THE *Cadillac* MAY, 1973 SERVICEMAN

NEW POWER ANTENNA NOW SERVICEABLE

NEW WINDSHIELD WIPER MOTOR SERVICE PROCEDURES

Fig. 2

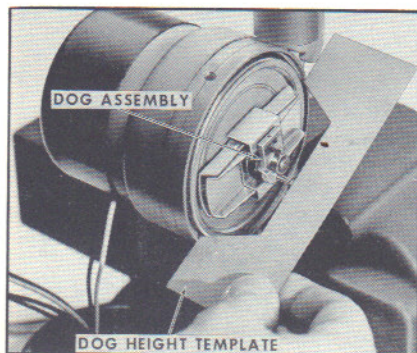
2. Using template provided, measure distance between top of longest pin on dog to base of drive housing, Fig. 2. Adjust as necessary.

bly), measure distance between top of longest pin on dog to base of drive housing, Fig. 2. Adjust as necessary.

Fig. 1

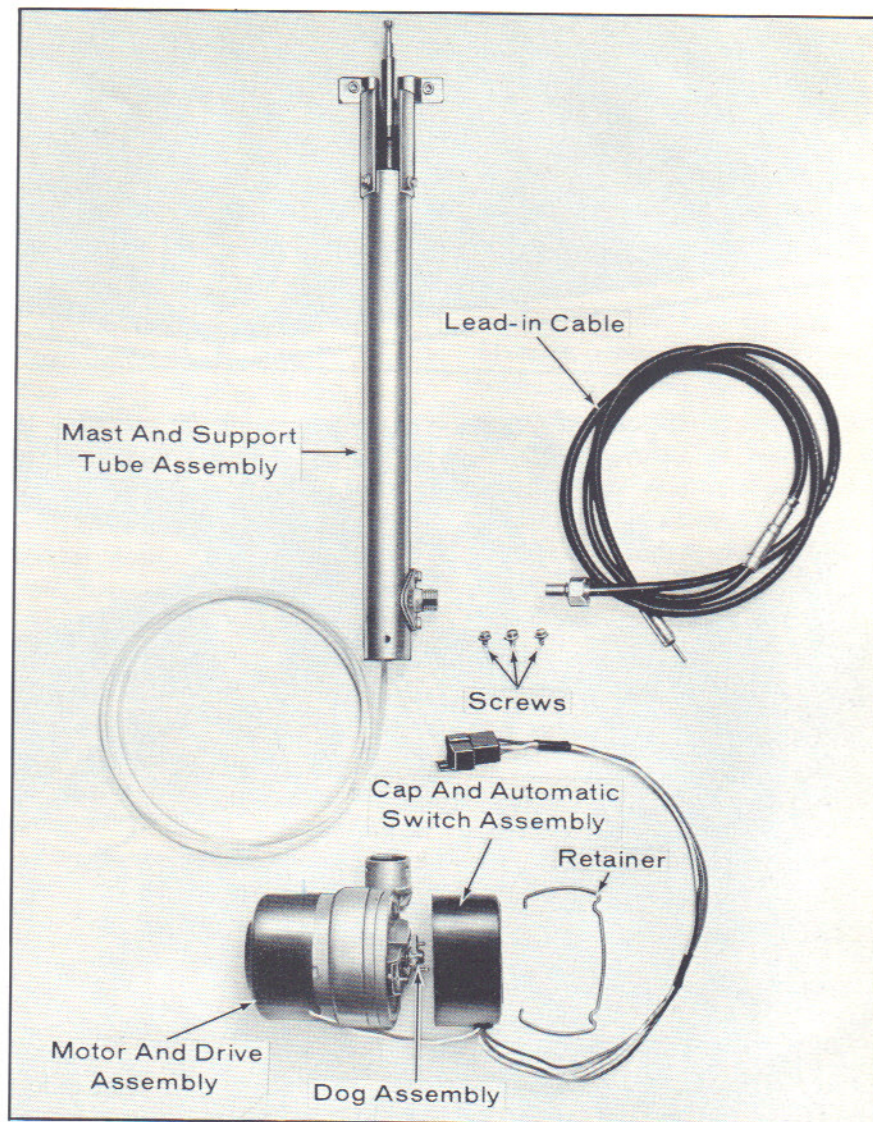
THE optional power antenna is serviceable on late 1973 cars effective with approximate Broadcast Nos. 256600, 378900 and 437375. The new antenna can be identified by a retainer that holds the cap with its automatic switch assembly to the drive housing, Fig. 1.

Fig. 3

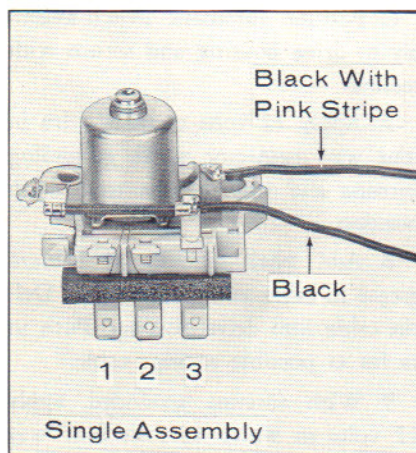
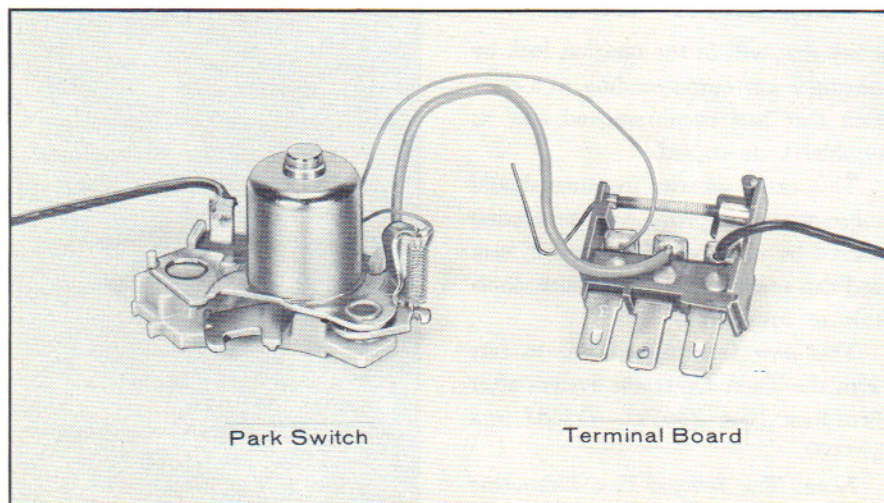
THE windshield wiper motor assembly utilizes a combined park switch and terminal board assembly, Fig. 3, on later 1973 cars. Previously, the park switch and terminal board have been separate units, Fig. 4.

The separate-type and the one-piece assembly are not interchangeable because the one-piece assembly has a redesigned gear box, washer pump and washer pump cover.

1. Resolder leads to park switch and terminal board assembly as required, Fig. 3.

Note: Solder black wire to No. 3 terminal, and black-with-pink-stripe wire to fixed contact post.

Fig. 5

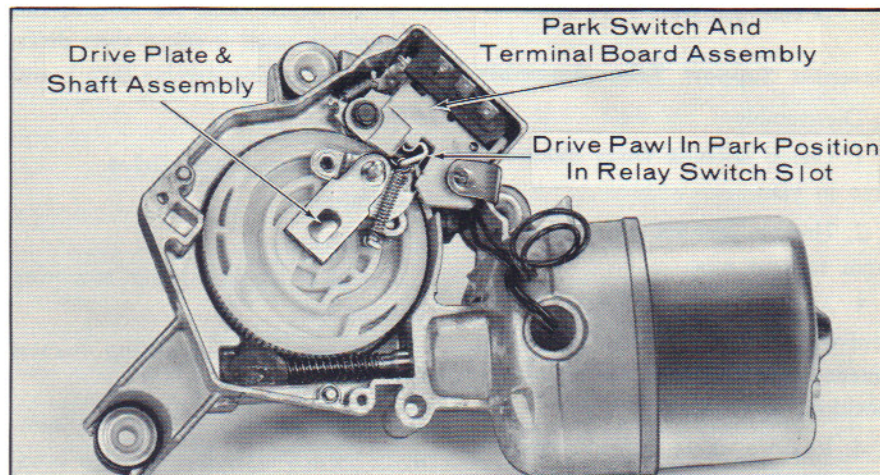
2. If wiper gear drive pawl is in Park position, Fig. 5, manually trip the relay latch arm toward the relay coil, and apply feed current to the center terminal of the wiper terminal board and ground to the motor case. The wiper motor will turn the gear, moving the drive pawl out of the Park position in the relay slot.

Fig. 6

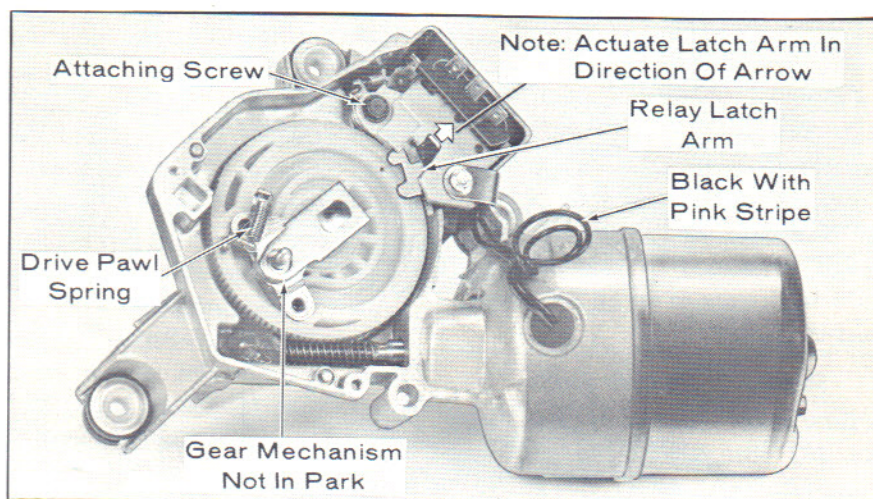
If wiper gear mechanism is not in Park position (drive pawl away from latch arm, Fig. 6), proceed to step 3.
